**County of San Diego**  
**Stormwater Quality Management Plan (SWQMP)**  
**For Priority Development Projects (PDPs)**

<b>Project Information</b>		<b>Development type</b> <input type="checkbox"/> New development <input checked="" type="checkbox"/> Redevelopment	
<b>Project Name</b>	VISTA II		
<b>Project Address</b>	143 Hannalei Drive, Vista, CA 92083		
<b>Assessor's Parcel # (APN)</b>	183-060-78-00, 183-060-84-00		
<b>Permit # / Record ID</b>	PDS2022-TM-5647/PDS2022- MUP-22-011		
<b>Project category (select one)</b>	<input type="checkbox"/> Commercial <input type="checkbox"/> Minor subdivision*		
	<input type="checkbox"/> Industrial <input type="checkbox"/> Major subdivision*		
	<input type="checkbox"/> Single family residential lot <input checked="" type="checkbox"/> Multi-family residential*		
*If residential, is a Homeowners Association (HOA) proposed? <input checked="" type="checkbox"/> Yes <input type="checkbox"/> No

# **PRIORITY DEVELOPMENT PROJECT STORM WATER QUALITY MANAGEMENT PLAN FOR VISTA II**

This PDPSWQMP presents a revision to the October 16, 2023 report pursuant to the County of San Diego plan check comments received January 24, 2024. The following text identifie

**VISTA II**  
**BMP-A1/ A2 CONFIGURATION**  
**VAULT TO PROPRIETARY BIOFILTRATION**

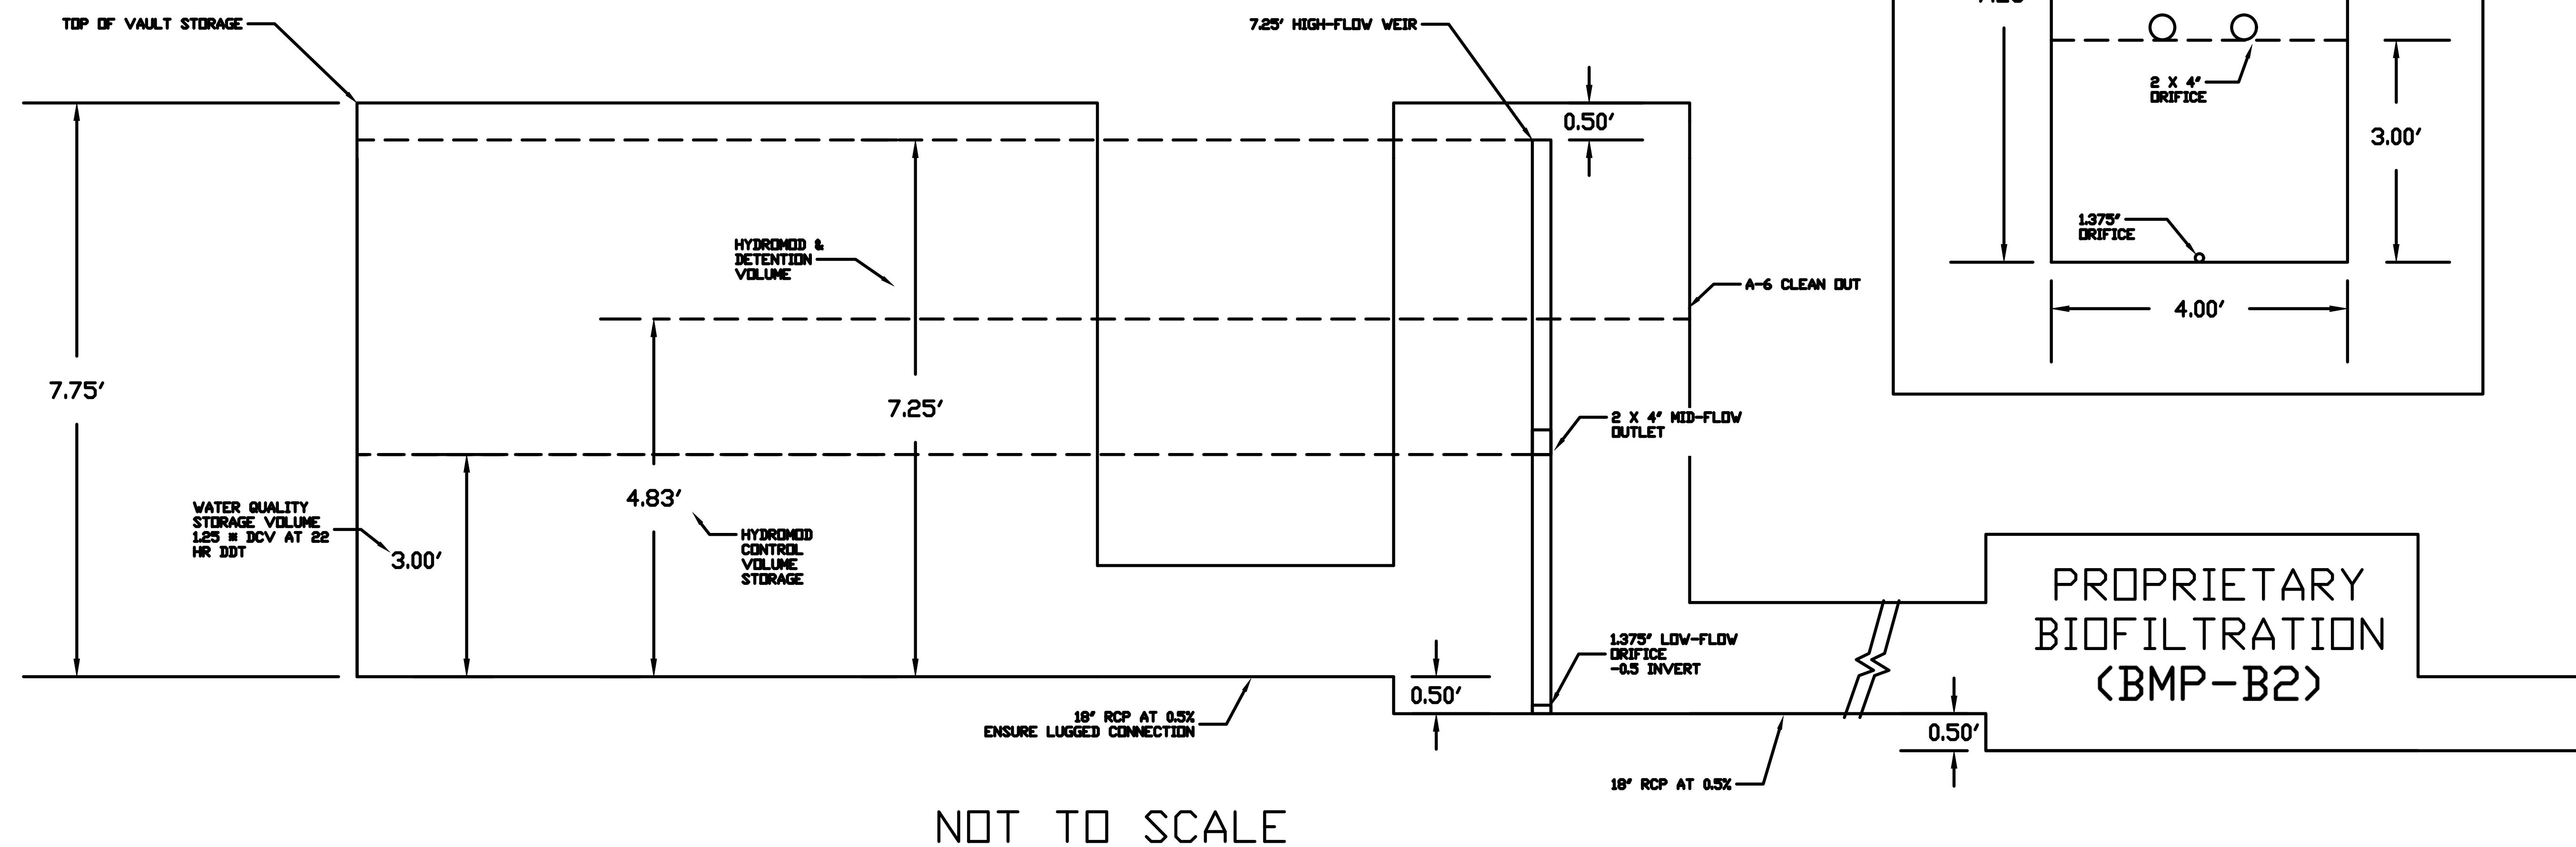
6-13a. Correct the portion of the DMA Exhibit showing the connections for BMP-A2 to be consistent with profile detail provided.

**DMA exhibit has been updated to show consistency with detail.**

**HYDROMODIFICATION  
EXHIBIT FOR  
VISTA II  
(PRE-DEVELOPMENT)**

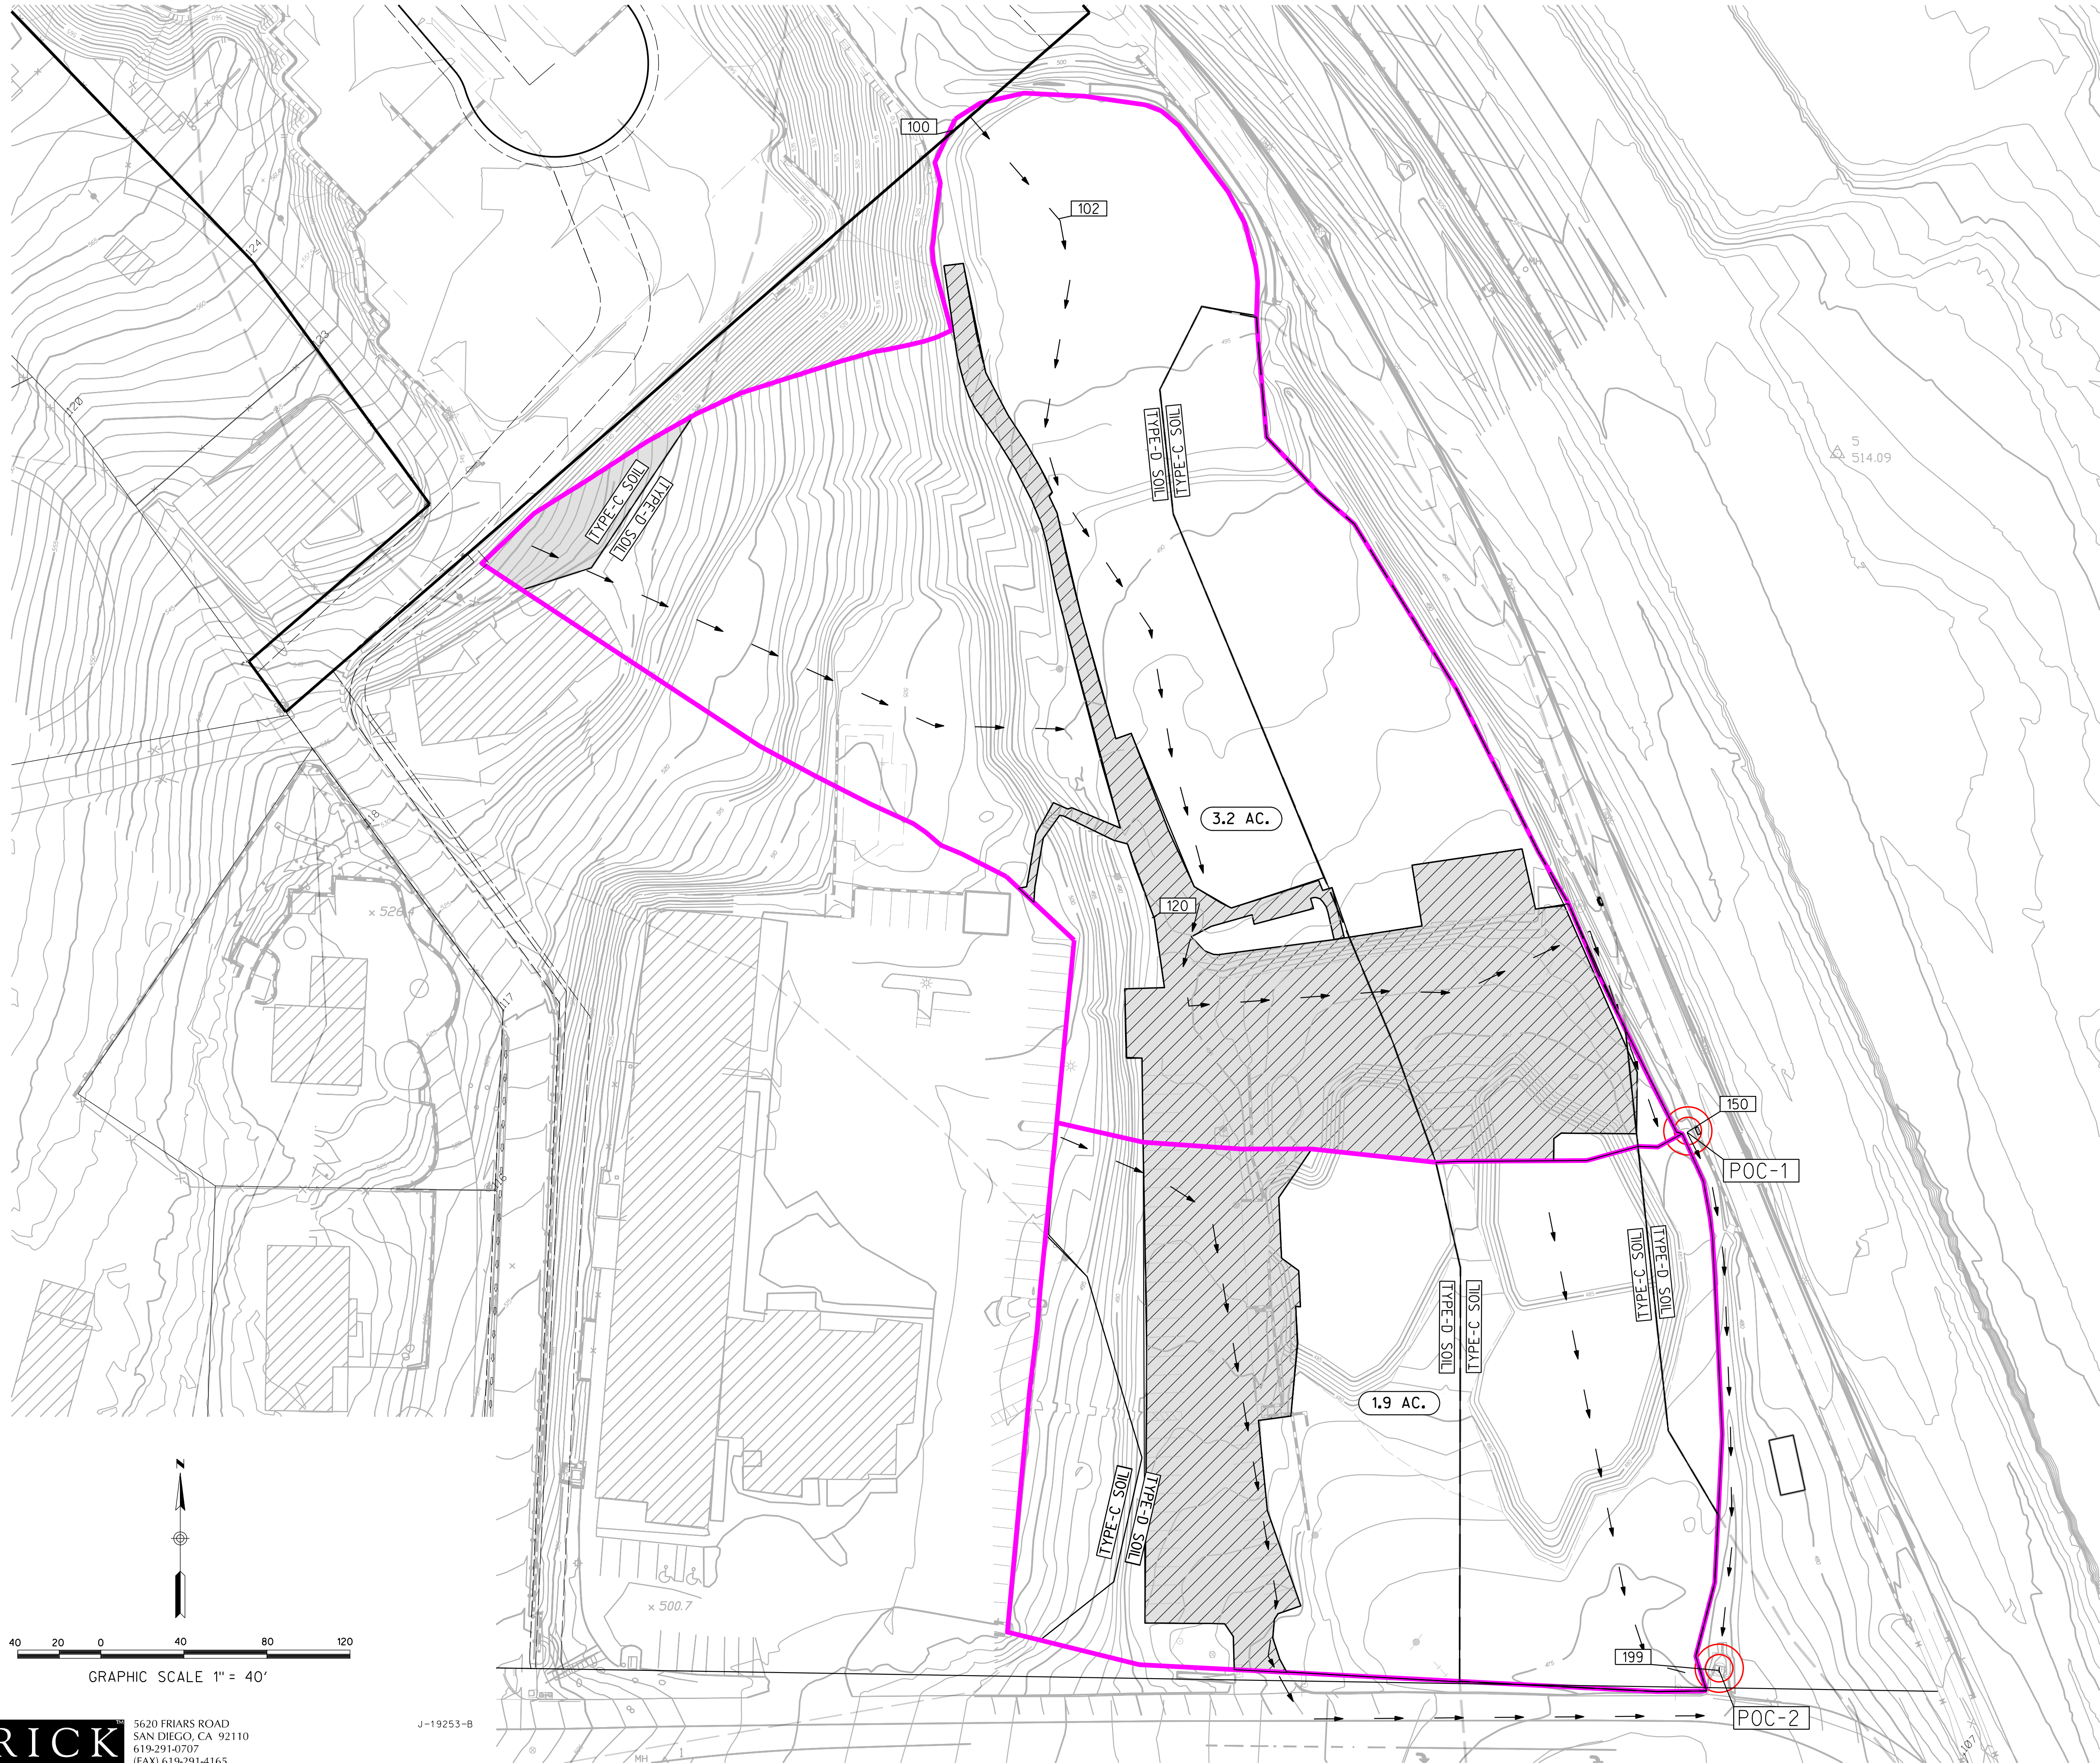
6-25a. 2nd Review Comment: SWMM Model:

The pre-project Hydromodification exhibit appears to indicate the underlying soil hydrological groups incorrectly toward the eastern side of the project. Correct to be consistent with the Soil Hydrologic groups from the NRCS data.

3rd Review Comment: From NRCS data, SbA soil is C soil & BID2 is a D soil. Please correct.

6-29. 3rd Review Comment:

**Response: Soil group labels have been updated in the pre-project hydromodification exhibit.**

**Response: The pre-project HMP exhibit has been updated to include current site grading.**

**DRAINAGE MANAGEMENT AREA EXHIBIT FOR VISTA II**

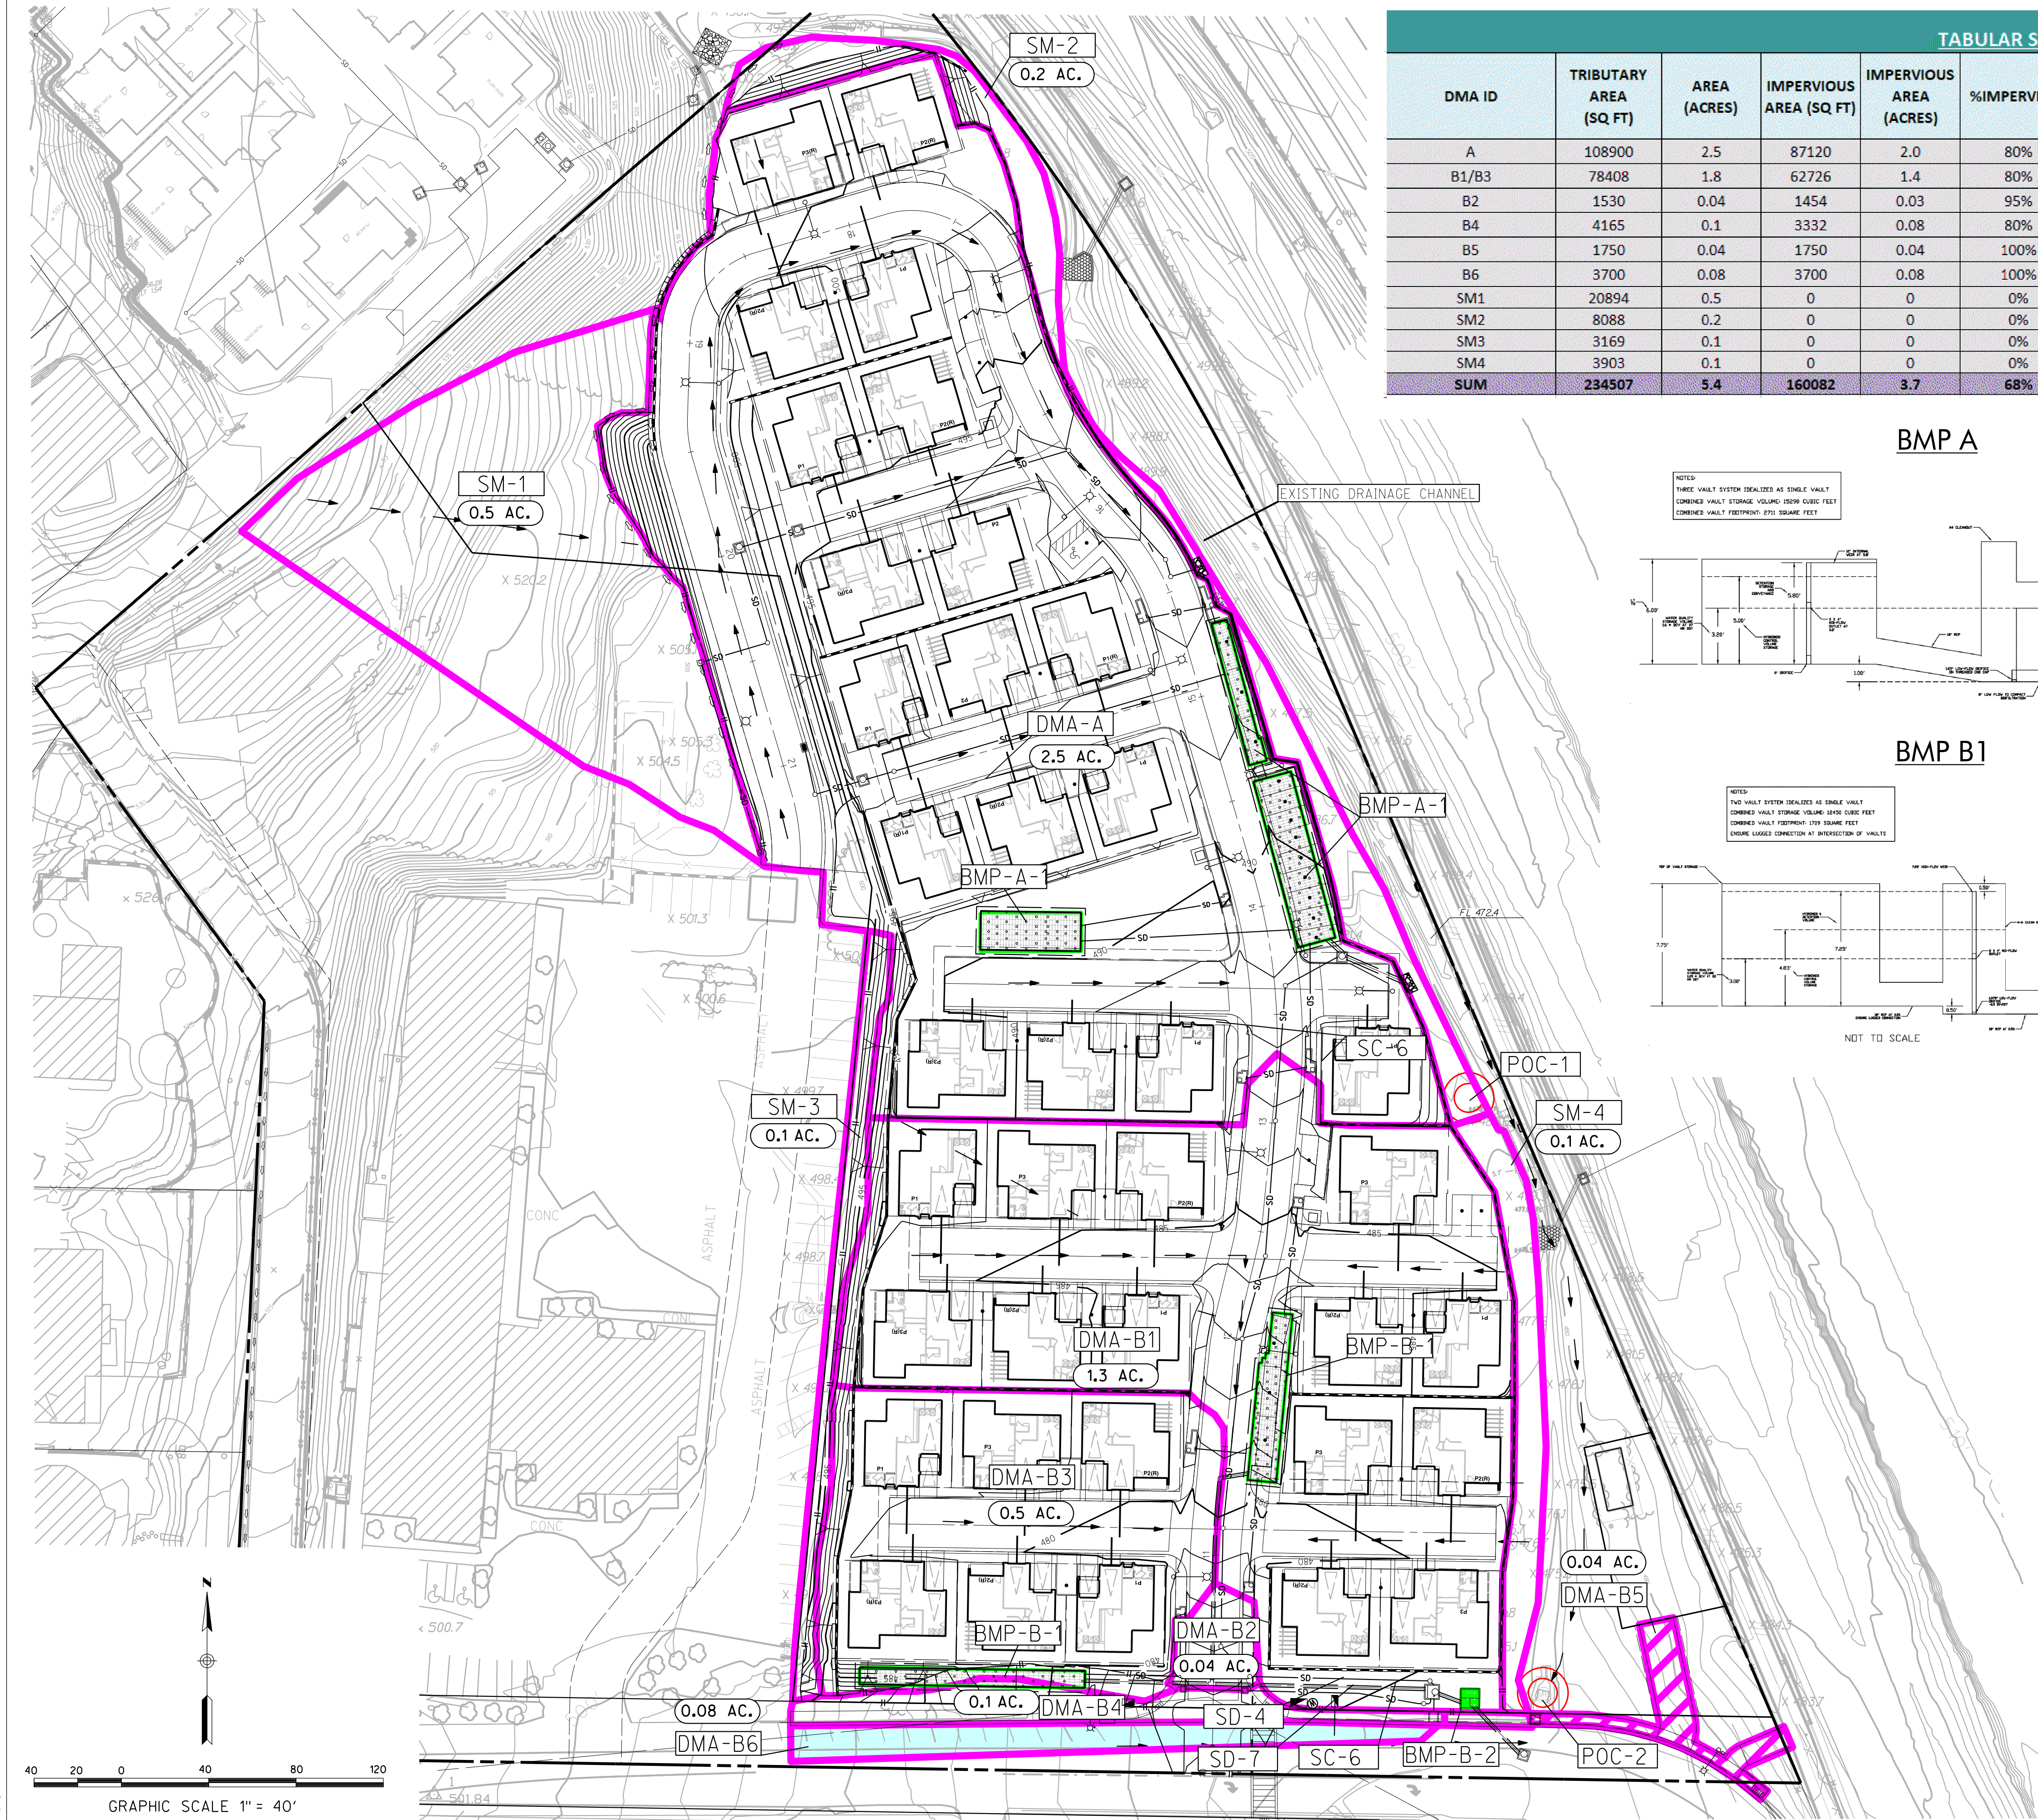
Based on a call with the County of San Diego on April 11th, 2024, it was requested to show the additional impervious area, which is proposed to connect the proposed sidewalk to the existing Inland Rail Trail (IRT), as a Drainage Management Area. It should be noted that this area (DMA-B5) will bypass the proposed BMP-B2 due to site constraints and existing impervious area (DMA-B6) has been directed to this BMP to offset the proposed improvements that cannot be feasibly treated. The proposed impervious area (DMA-B5) is approximately 1,750sf and the existing impervious area delineated in DMA-B6 that will be treated instead is 3,700sf. Calculation in Attachment 7.4 show that the proposed compact biofiltration system (BMP-B2) has capacity for this. The DMA exhibit and associated tables and calculations have been updated.

3rd Review Comment: The unfactored DCV values differ between Pollutant Control Worksheet B.1, the DMA exhibit table, and Tabular summary of DMAs provided in Attachment 7.4 for DMA B1/B3, DMA B2, and DMA B4. Revise all to be consistent with the analysis.

**Response: The DCV values have been updated to be consistent.**
